ASSESSMENT REPORT

Cobaki Lakes Residential Community Development Concept Approval MP 06_0316 (MOD 9)

Figure 3: Proposed Swamp Sclerophyll Forest EEC Offsets (source: Amended Site Revegetation and Regeneration Plan (JWA, 2017))

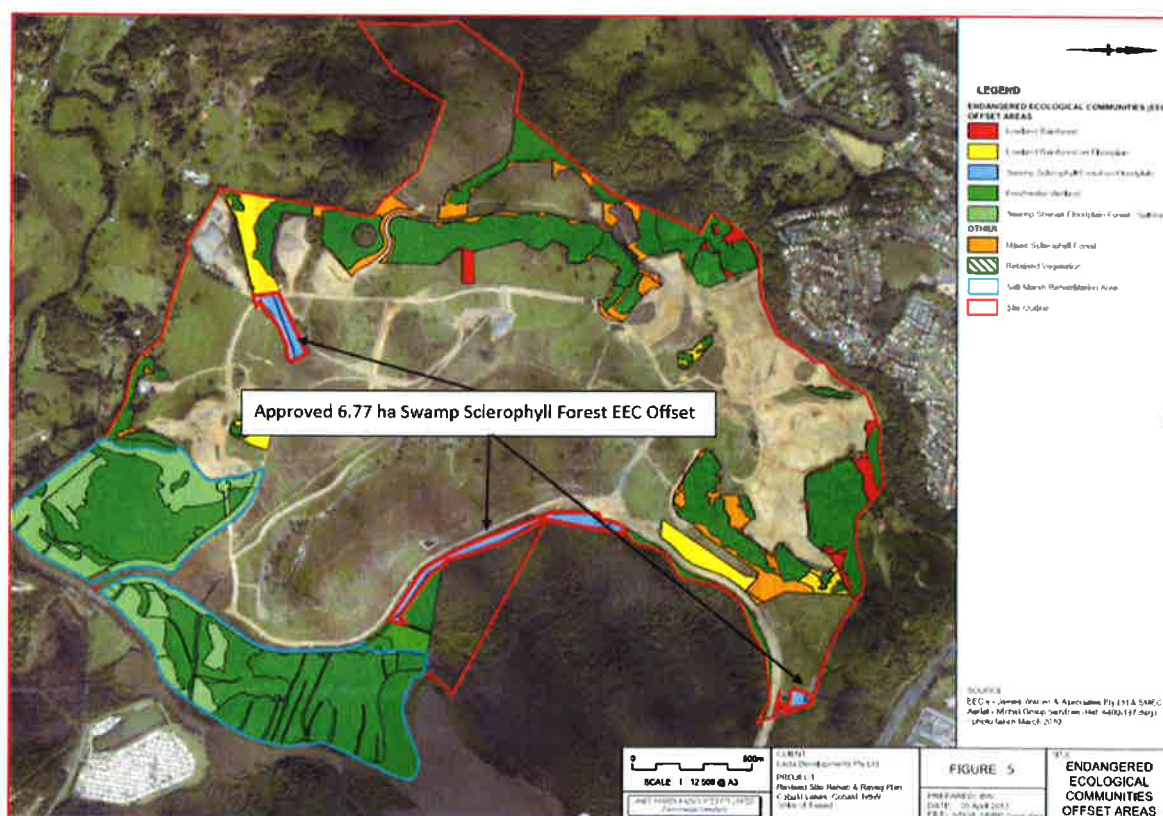
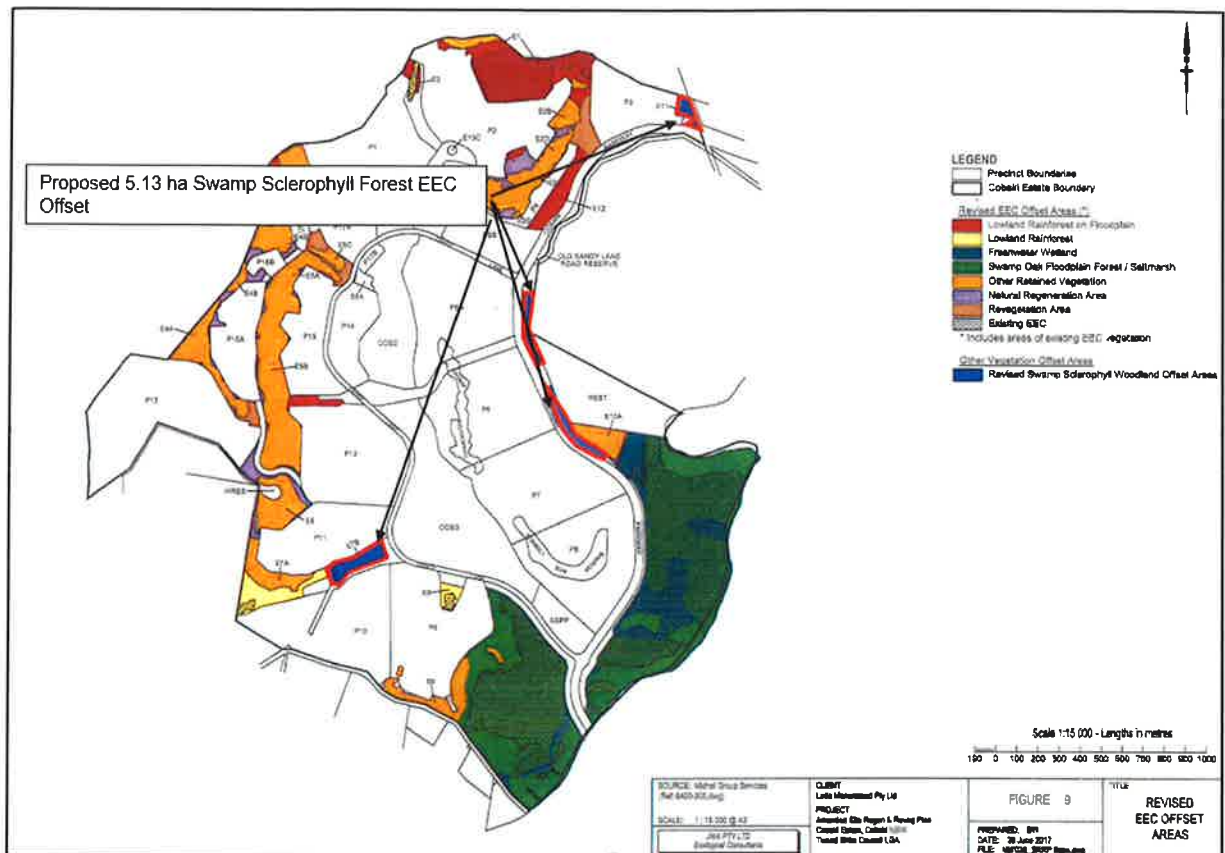
- the proposal would decrease the SSF EEC offsets from 22.7 ha (6.77 ha on-site and 16 ha offsite) to 14 ha;
- the shortfall in the on-site offset area should be addressed by expanding the approved SSF

- the Draft Offset Strategy seeks to change the layout of the on-site offset areas. These changes would:
 - reduce patch sizes and increase edge effects in several rehabilitation areas;

- the proposal would decrease the total offsets required for the clearing of 3.8 ha of SSF EEC from 22.7 ha (6.77 ha on-site and 16 ha offsite) to approximately 14 ha;

- the proposed offsets for the SSF EEC are inconsistent with the recommendations of the Umwelt review;
- the management regime and development activity undertaken in and around the SSF EEC since the determination of the Concept Plan may have reduced the ecological integrity of this EEC. Accordingly, the vegetation surveys undertaken in 2016 should not be relied upon to determine the ecosystem and species credits required to offset the SSF EEC;

Based on the Umwelt methodology and the reduced on-site offset of 5.13 ha (equivalent to 33 ecosystem credits) the proposal would require 159 ecosystem credits to ensure a total of 192 ecosystem credits will be provided to offset the clearing of 3.8 ha of SSF EEC. The Department has recommended modifications to Term C19(2) to ensure this occurs.

Figure 5: Proposed Areas of Lowland Rainforest on Floodplain EEC (source: Revised Site Revegetation and Regeneration Plan (JWA, 2017))

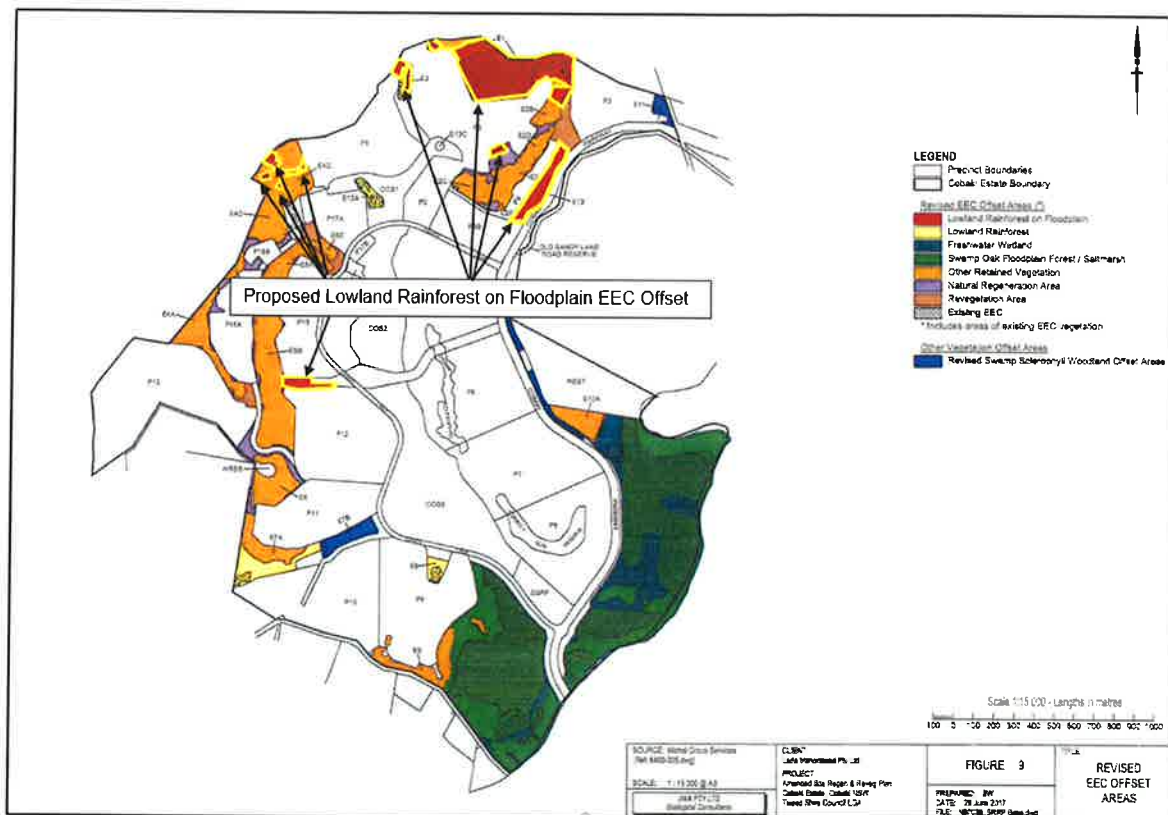
- there are discrepancies between the Proponent's BAR and biobanking calculations; and
- the proposal does not include any justification to support the reclassification of the Lowland Rainforest on Floodplain EEC.

The Department notes both the Council and the OEH advised insufficient justification has been provided to support the proposed reclassification of the Lowland Rainforest on Floodplain EEC and the proposed reduction in the on-site offset area for the Lowland Rainforest communities.

The Department agrees with the ELA review that there is insufficient information to support the proposed reclassification of the Lowland Rainforest on Floodplain EEC. Notwithstanding, the Department notes that as both Lowland Rainforest communities are comprised of the same PCTs, the offset requirements are the same regardless of their classification.

The Department has reviewed the proposed 0.34 ha reduction in the on-site offset areas for the Lowland Rainforest on Floodplain EEC and concludes the proposal is acceptable as the offset areas identified in the Amended Site Regeneration and Revegetation Plan would continue to generate sufficient ecosystem credits to offset the removal of this vegetation.
